LOT / UNIT 733	PHASE 7	MODEL 39-3573 A The Cedarvale	
-------------------	------------	----------------------------------	--

Sales Selection Sheet  
Country Lane

Sketch #9

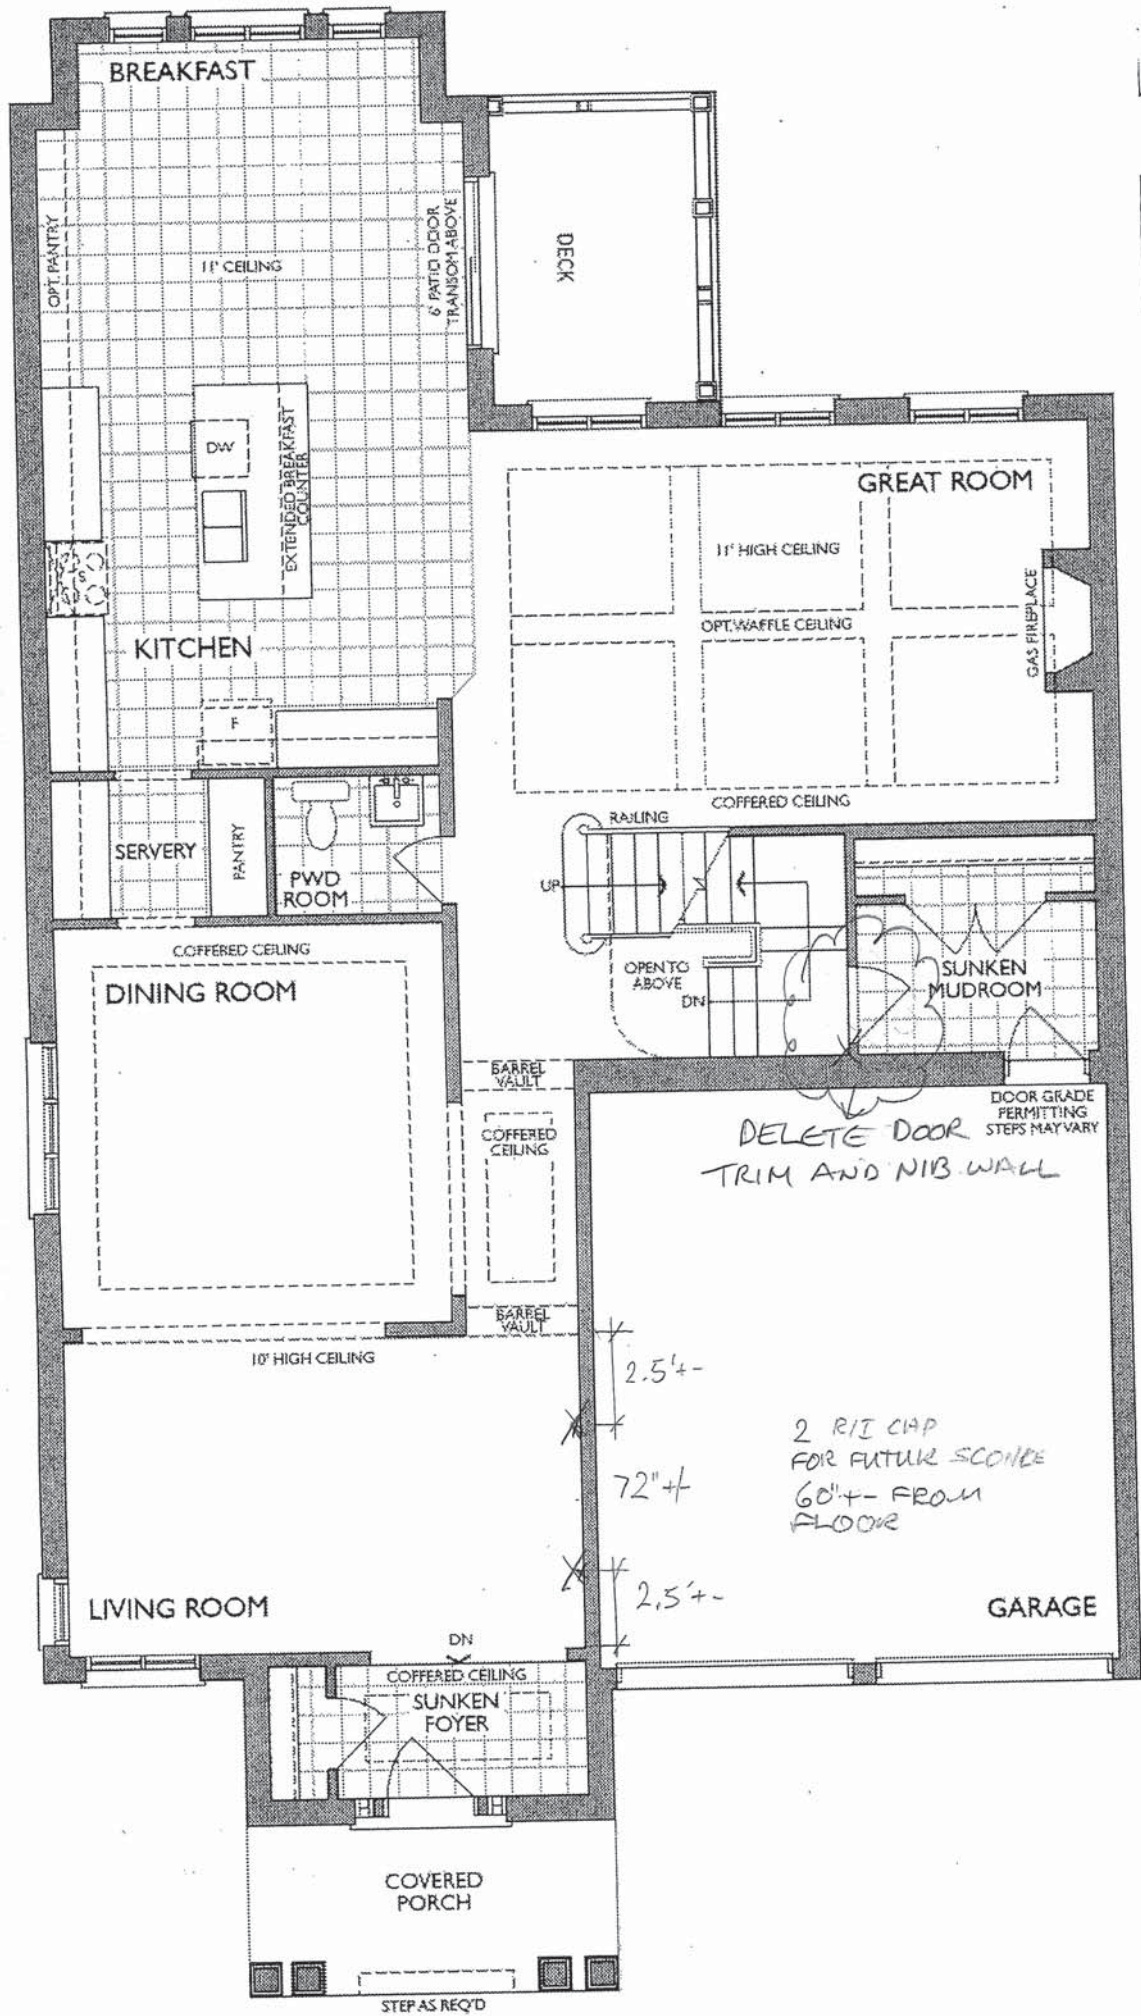
1	MUD ROOM - DELETE DOOR,NIB WALL AND TRIM	Qty: 1.0000
151,181	Note: SEE SKETCH # 9

2	BEDROOM 3 - CLOSET LIGHT SWITCH LOCATION	Qty: 1.0000
151,182	Note: SEE SKETCH # 10	
3	THROUGHOUT - DELETE 2 R/I CAP LIGHT (FOR FUTURE SCONES) FROM HALL WAY (SEE ORIGINAL SKETCH # 2)	Qty: 1.0000
151,183	Note: INSTALL 2X R/I CAP LIGHT FOR FUTURE SCONES IN LIVING ROOM 2.5' +- FROM EACH END OF ROOM (72"+- FROM EACH OTHER) 60" +-FROM FLOOR SEE SKETCH # 9
